Subject: Responses to NRC Staff Questions  
R. E. Ginna Nuclear Power Plant  
Docket No. 50-244

Attached are responses to questions from the NRC staff concerning our Application for Amendment to Operating License dated April 2, 1984.

# AUXILIARY BUILDING SFP AREA

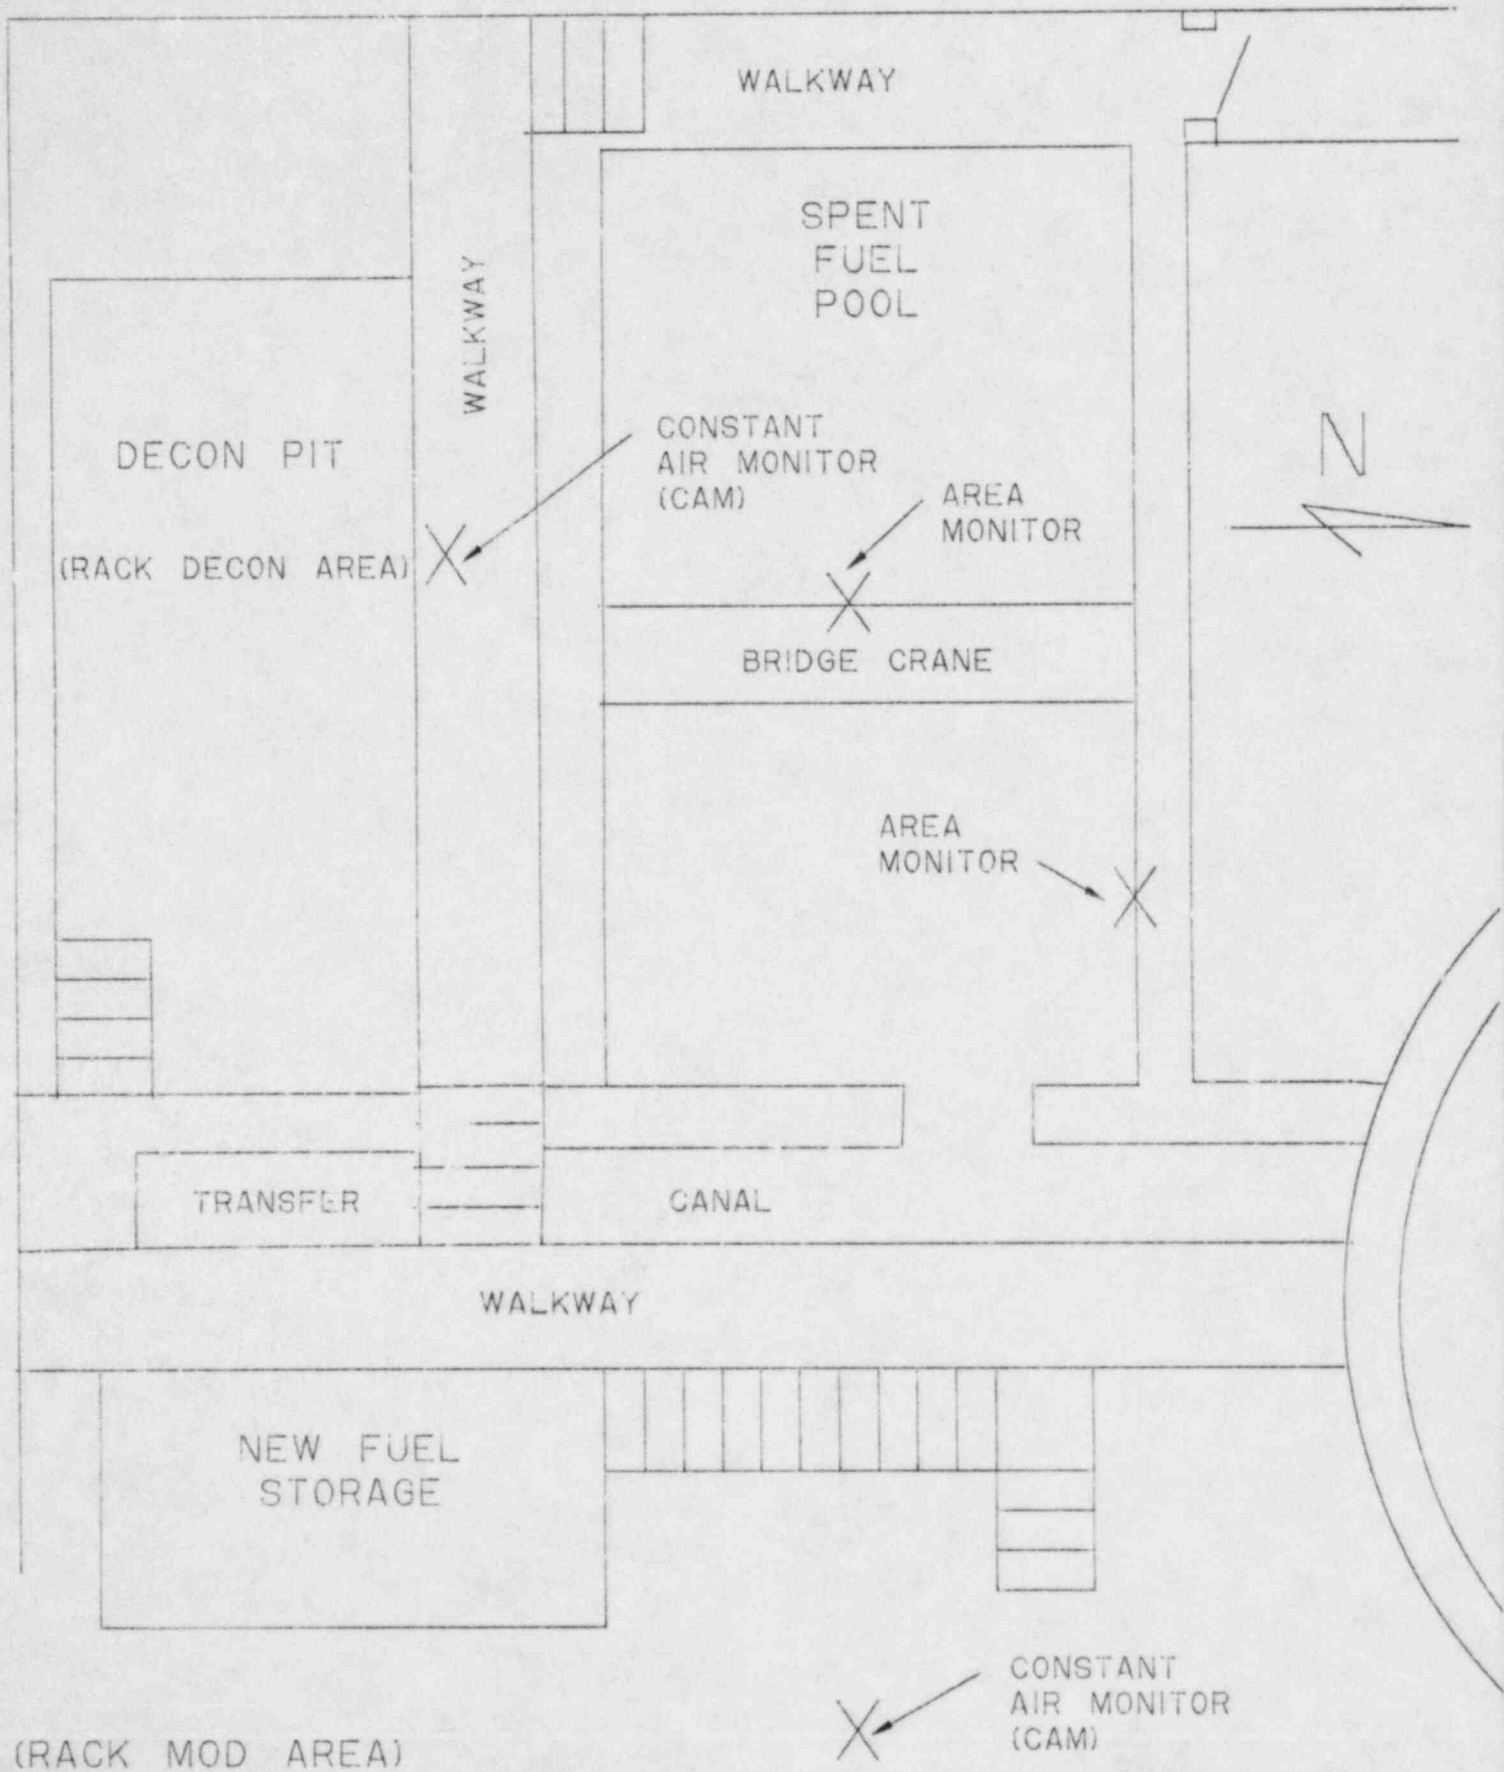
Question 6. Section C.2.9 of Regulatory Guide 8.8 states that the use of radiation monitoring systems to measure dose rate and airborne radioactivity levels in selected plant areas can reduce the exposure of station personnel in these areas. Describe your plans for providing area radiation and airborne radioactivity monitoring in the spent fuel pool area during the spent fuel pool storage rack modification. Provide a layout drawing of the spent fuel pool area showing the location of all area monitors and air samplers.

Response: Area radiation and airborne radioactivity monitoring will be performed in the spent fuel pool area during the rack modification. Radiation area monitors will be provided on the fuel handling crane bridge and on the north wall of the SFP area. In addition, items removed from the SFP will be surveyed by portable survey instruments. The racks will be removed from the pool and placed in the Decon Pit where they will be decontaminated in an enclosed area. The enclosure will be exhausted by an air mover with HEPA filters. A constant air monitor (CAM) will be used to monitor for airborne radioactivity outside the enclosure. Breathing zone samplers will be worn by personnel inside the enclosure. After decontamination, the rack will be moved to another enclosure on the auxiliary building operating floor. Air monitoring will be provided in a similar fashion as described for the decon pit area. Grab samples will be taken for airborne radioactivity as required by conditions or to provide additional information.
